February 8th, 2008 CSB070001

Subject: Response to Water PER Comments

Nolte Associates, Inc. has received your comments dated November 5, 2007 regarding the Water Preliminary Engineering Report submitted to the Construction Programs Bureau on October 9, 2007 and offers the following responses.

Revised Water Vicinity Map

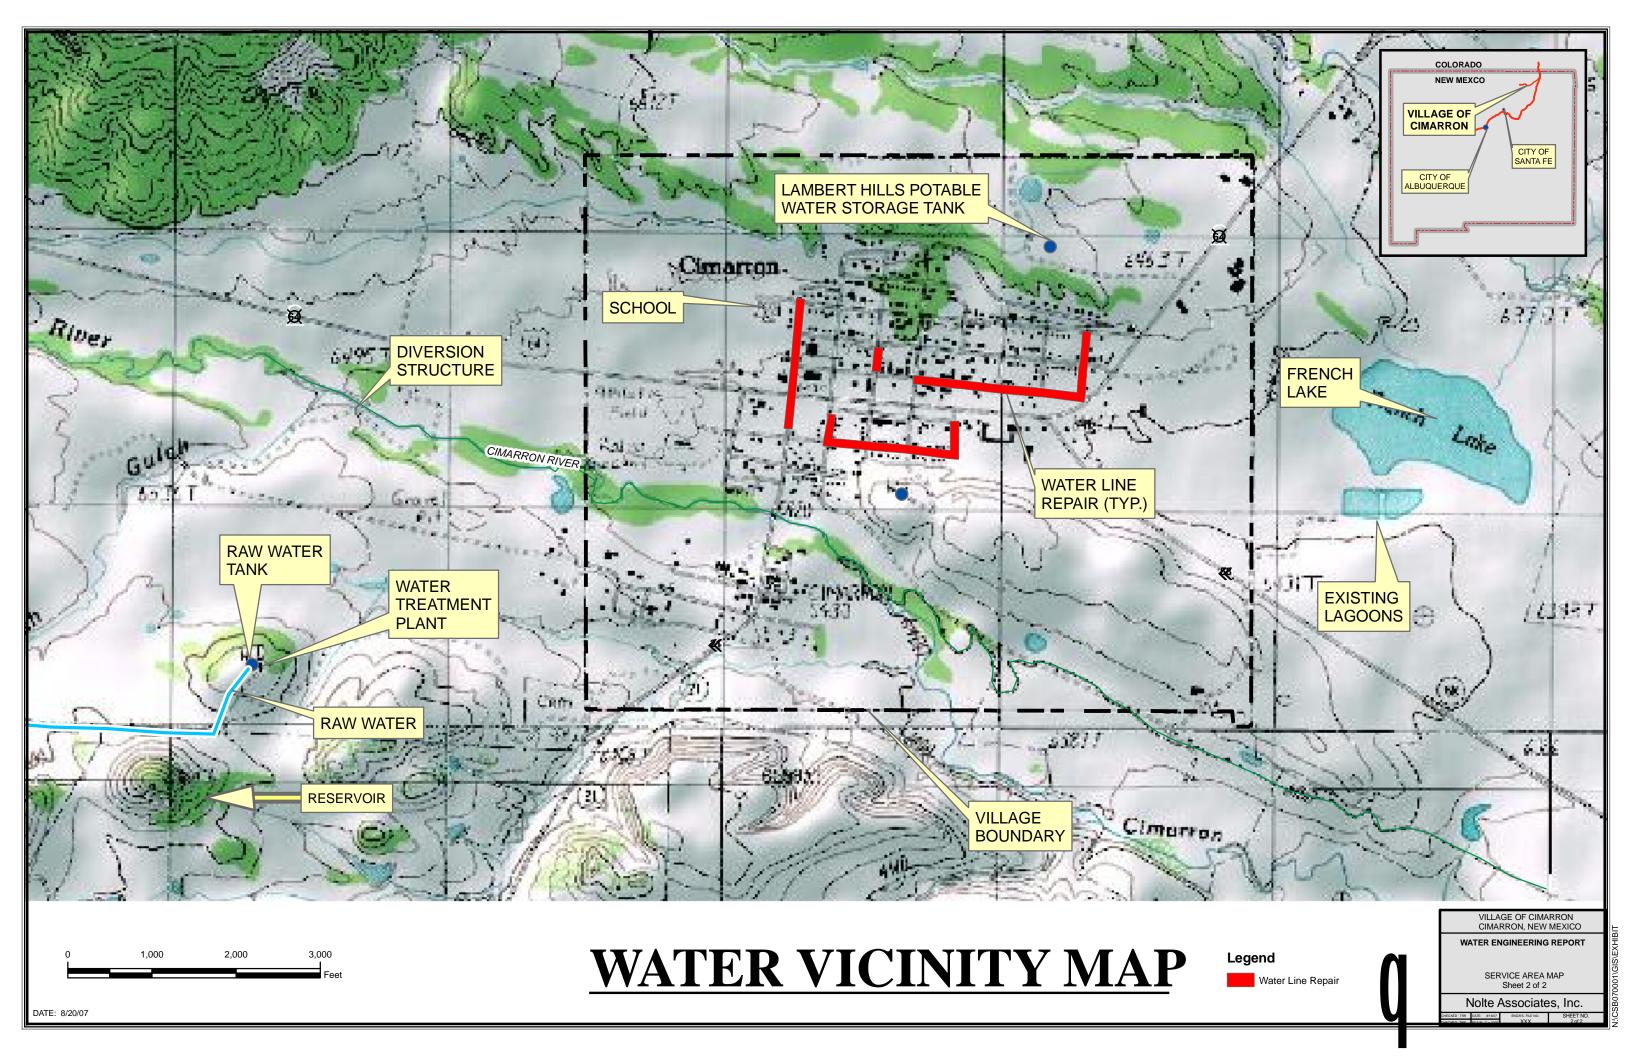
2. Appendix B: Please show the service area/Village boundary to the map

Please see the revised Water Vicinity Map added to Appendix B of the revised Water PER
